COMMENTS ON THE STRATFORD REDEVELOPMENT PROJECT
from the Zilker Neighborhood Association (June 6, 2018)

CITY OF AUSTIN – DEVELOPMENT SERVICES DEPARTMENT
SITE PLAN APPLICATION – MASTER COMMENT REPORT

Figure 34:
Examples of fully-shielded light fixtures.

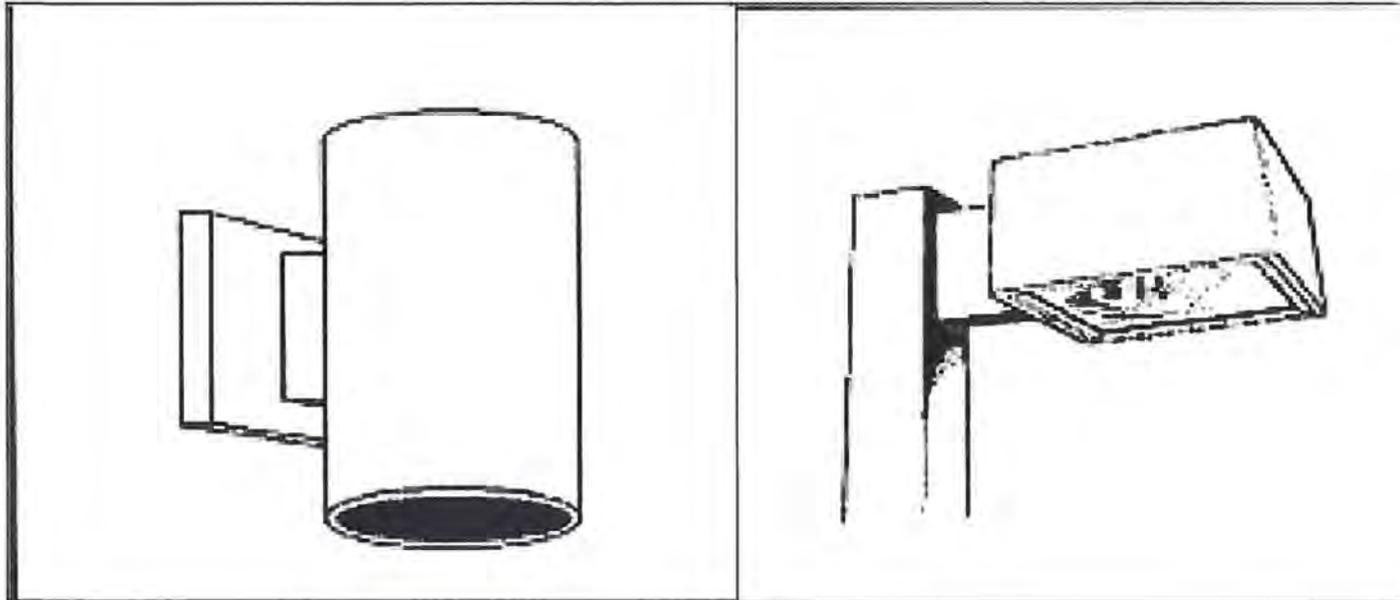
- SP 14. Include the following note on the site plan page: **"All exterior lighting will be full cut-off and fully shielded in compliance with Subchapter E 2.5 and will be reviewed during building plan review. Any change or substitution of lamp/light fixtures shall be submitted to the Director for approval in accordance with Section 2.5.2.E."** **Add Note and figure**

Also include Figure 34 from Section 2.5. on the site plan sheet. **The proposed light is identified on sheet 8 and is in compliance with figure 34.**
